City of Alexandria, Virginia

MEMORANDUM

DATE: SEPTEMBER 20, 2022

SUBJECT: 4th CONCEPT REVIEW OF 899 AND 999 NORTH HENRY STREET
BAR CASE # 2022-00175

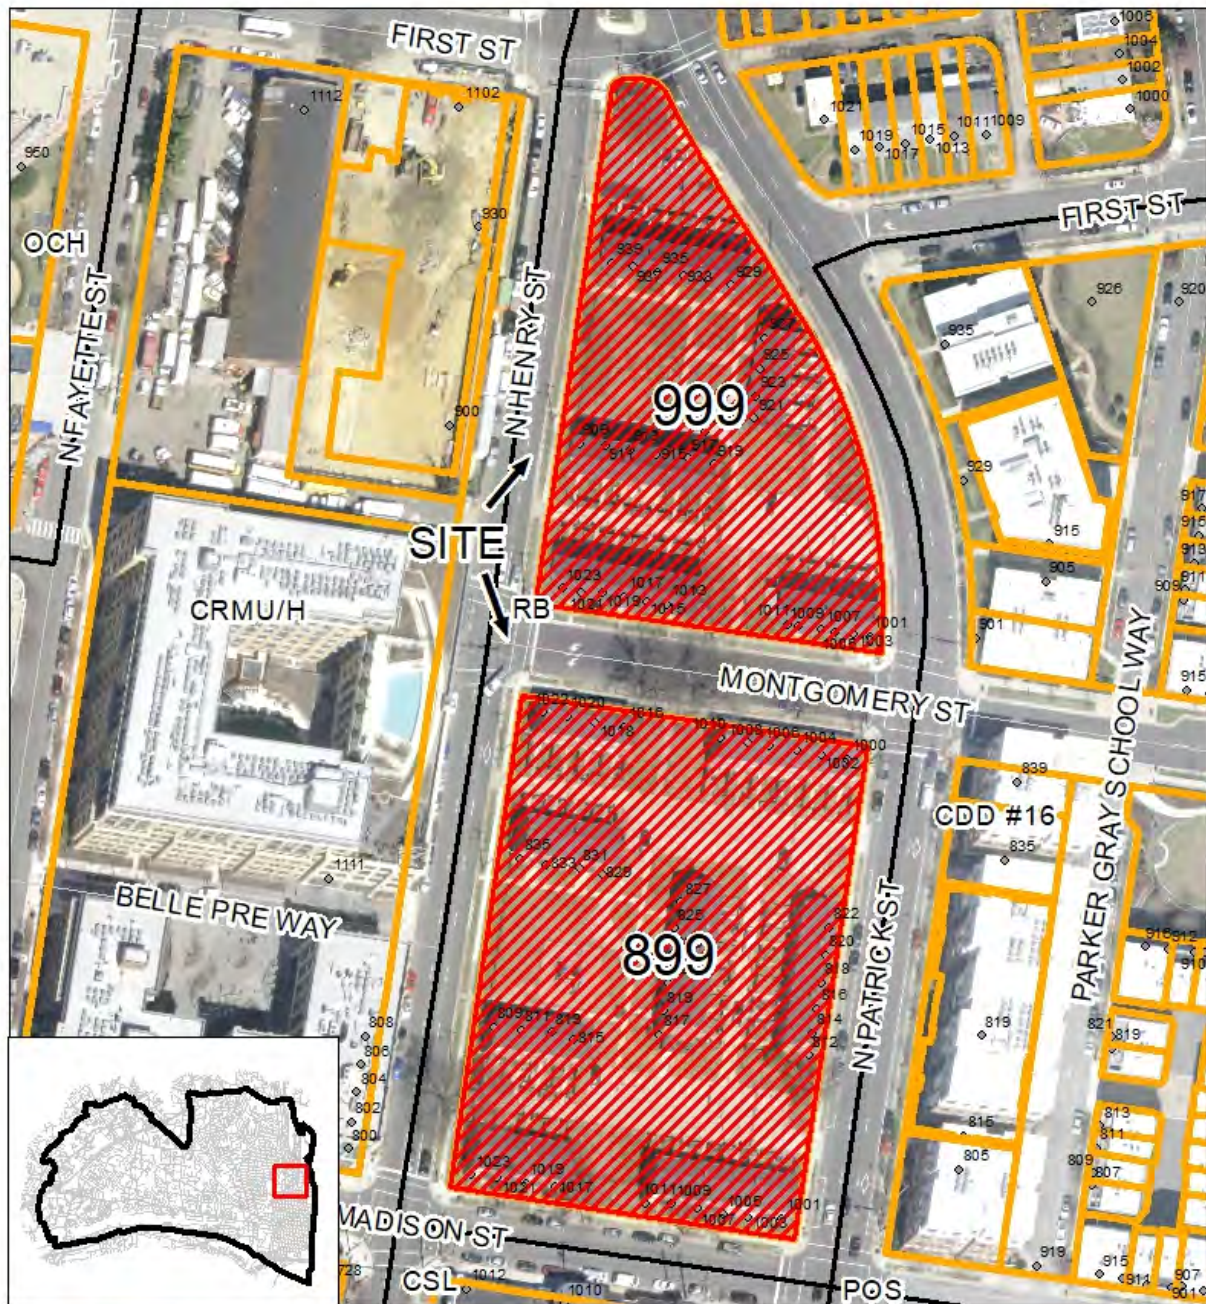
On July 20, 2022, the BAR held a special work session to review the revised design for the project. Board members noted the responsiveness of the applicant to the comments from the previous submission and indicated that the proposed design was an improvement over the initial one. Some items discussed by the Board include the following:

- The connectivity between the sidewalk and the interior courtyard at the north building.
- The physical presence of the gateway element at the north end of the north building.
- The extent of publicly accessible open space around the building.
- The overall size and height of the proposed buildings.
- A desire for the building to be made up of individual parts that are similar in scale and style to those found within the historic district.
